**FACT SHEET/STAFF REVIEW**  
**Closed Record Hearing before the Dayton City Council**  
**Tuesday, April 11, 2023**  
**Preliminary Plat Application by Mitchell Mathews**

“I move to adopt the Findings of Fact and Conclusions of Law contained in the staff report and approve the Jasper Pines Preliminary Plat to Dayton with the listed Conditions of Approval as recommended by the Hearing Examiner.”

FILE No. :	D-04-22
DATE :	APRIL 2022
SCALE :	1" = 50'
DESIGN :	B.A.M.
DRAWN BY :	B.A.M.
DRAWING NAME :	JASPER PINES

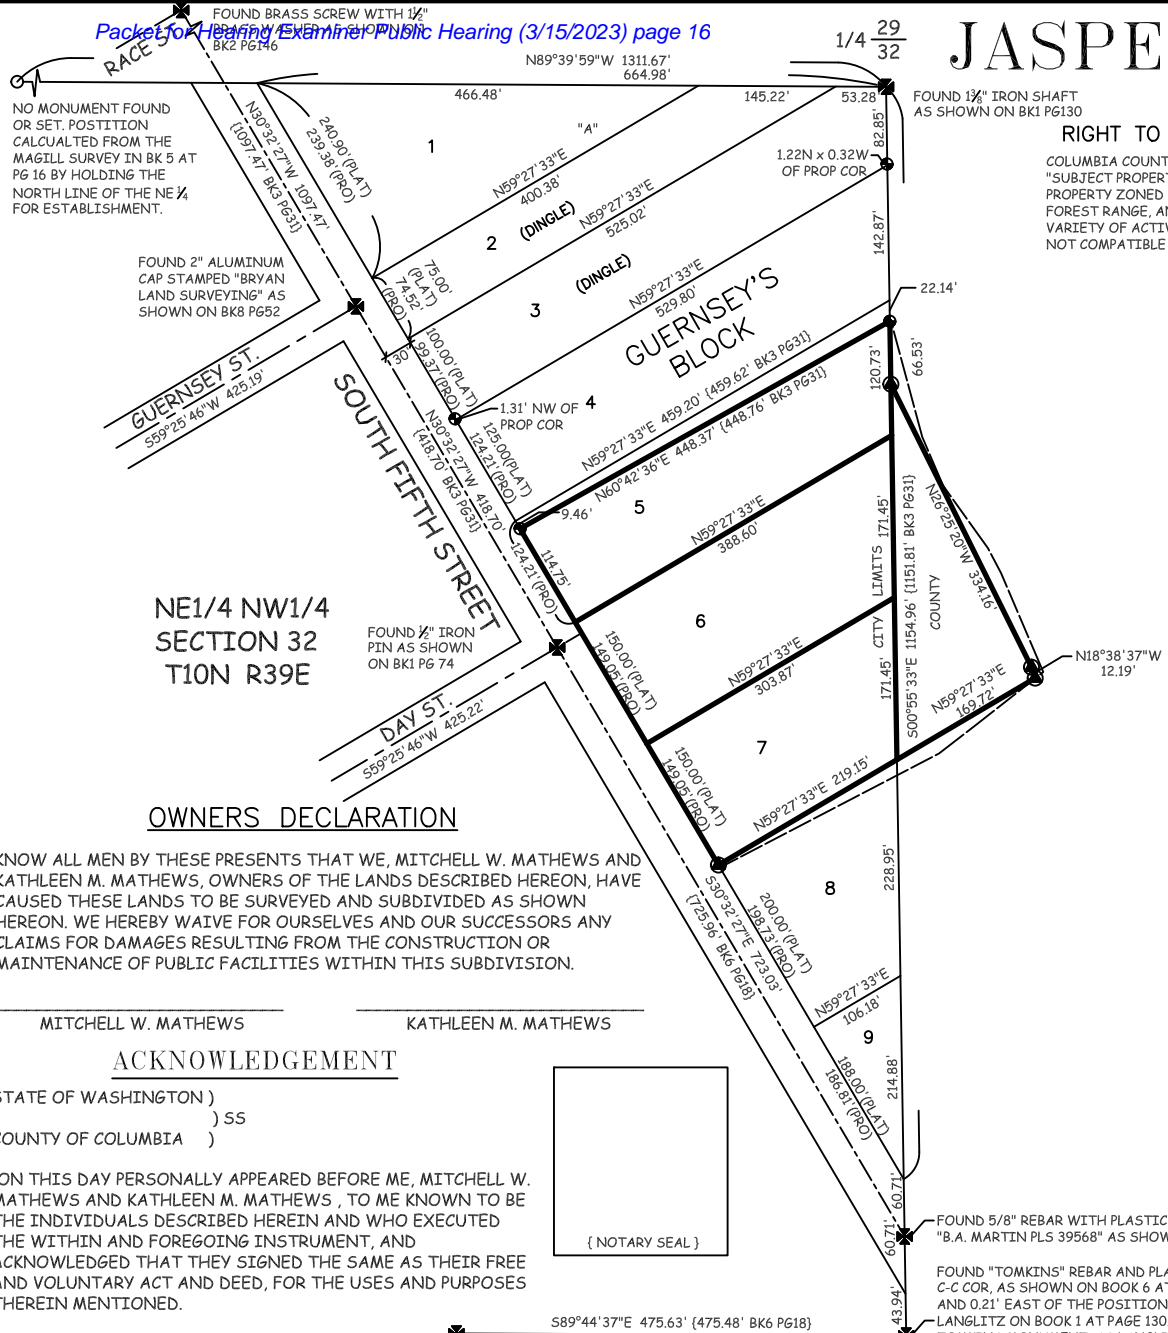
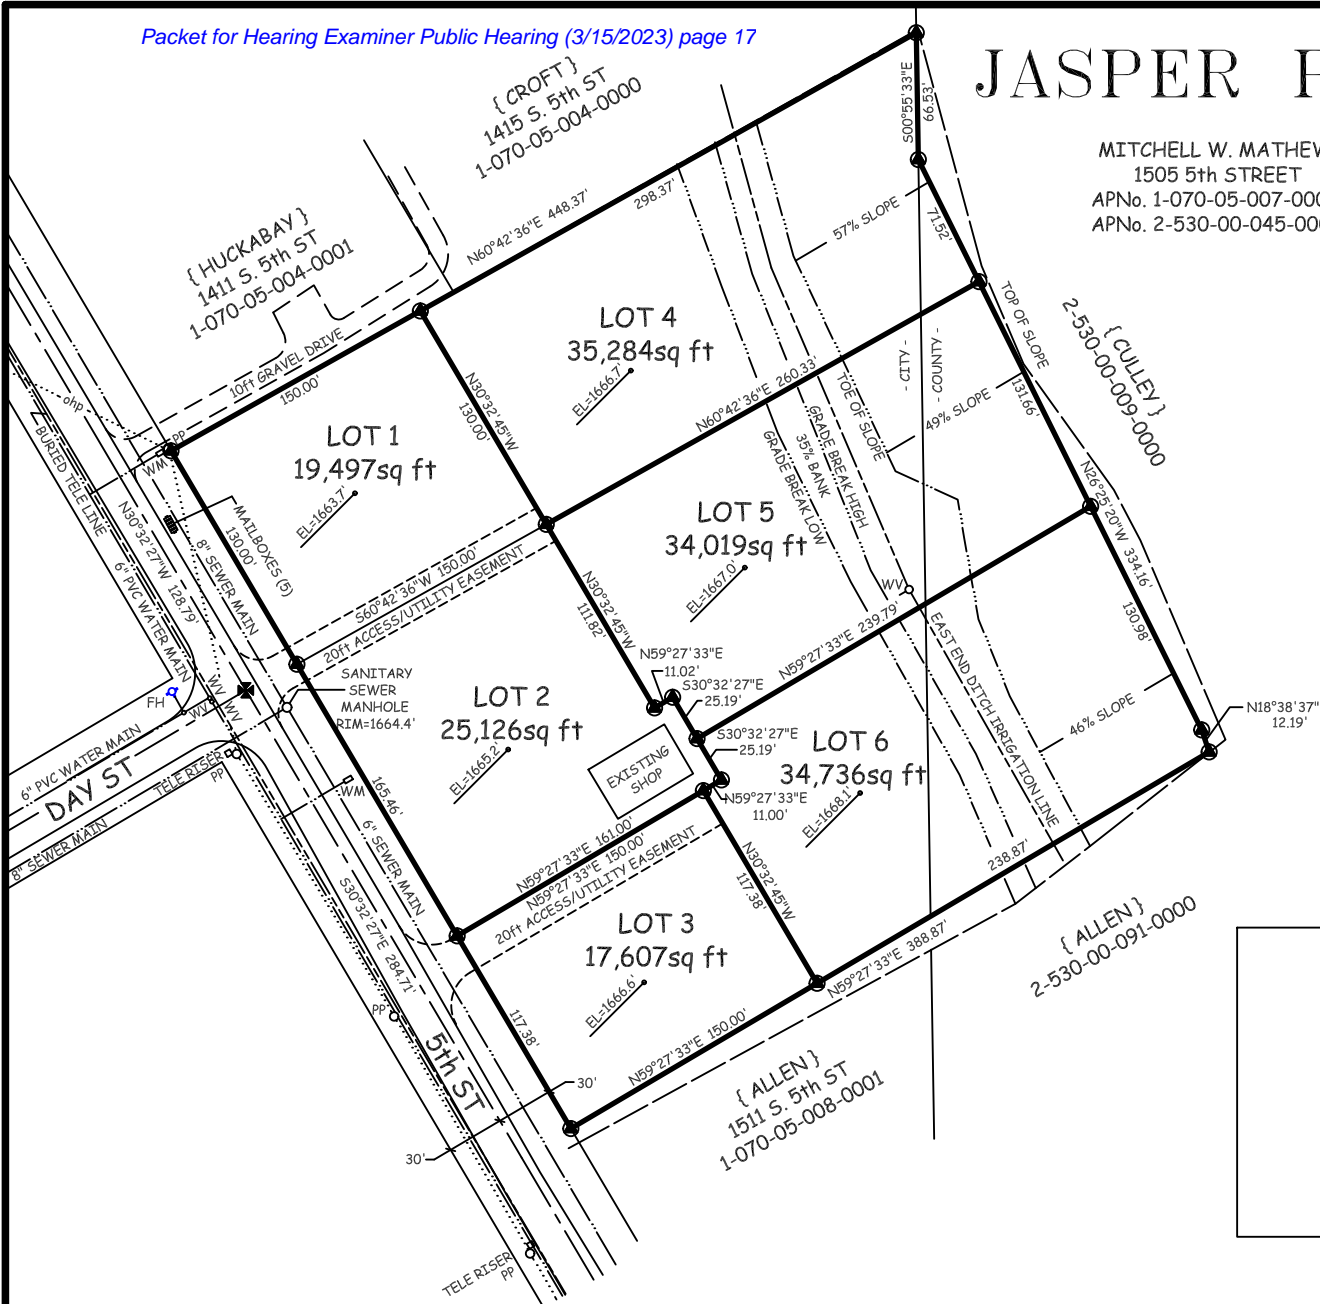
- a. Add Resource Lands Statement per DMC 19-01.200.
- b. Add Legal description of land being subdivided per DMC 19-04.040(B), WAC 332-130-050(f)(v), and RCW 58.09.060(1)(c).
- c. It appears from aerial imagery that additional buildings exist on Lots 1 & 2 and buildings exist immediately adjacent to lots 3 & 4. If these structures still exist, then they need to be shown on the preliminary plat per DMC 19-04.040(F) and WAC 332-130-050(1)(f)(vii).

- d. Add Block designation to the plat per DMC 19-04.040(I)<sup>2</sup>.
  - e. Add the Section-Township-Range and quarter-quarter of sections per WAC 332-130-050(1)(A) and RCW 58.09.060(1)(c)<sup>3</sup>.

- f. Auditors Certificate – Change date to 2023.
  - g. Notary Acknowledgement – Change date to 2023.
4. **Dayton City Planning (by ABHL, Inc.):**
- a. Mitchell Mathews, property owner, submitted an application for a preliminary plat on April 26, 2022 and resubmitted on February 2, 2023 after one of the parcels was annexed by the City. The City deemed the application complete as of February 2, 2023.

- a. Include a Legal description of the land being subdivided per WAC 332-130-050(f)(v), and RCW 58.09.060(1)(c)
- b. Per City Code 19-04.120(G) Please update the Surveyors Certificate on page 1 to include language as required: THIS SURVEY COMPLIES WITH ALL THE STANDARDS AND GUIDELINES OF THE "SURVEY RECORDING ACT" CHAPTER 58.09 RCW AND WAC 332-130.
- c. Show any existing structures and other applicable features per WAC 332-130-050(1)(f)(vii).
- d. Add the Section-Township-Range and quarter-quarter of sections per WAC 332-130-050(1)(A) and RCW 58.09.060(1)(c); this information needs to be on the first page and visible at the top of the page for indexing purposes.
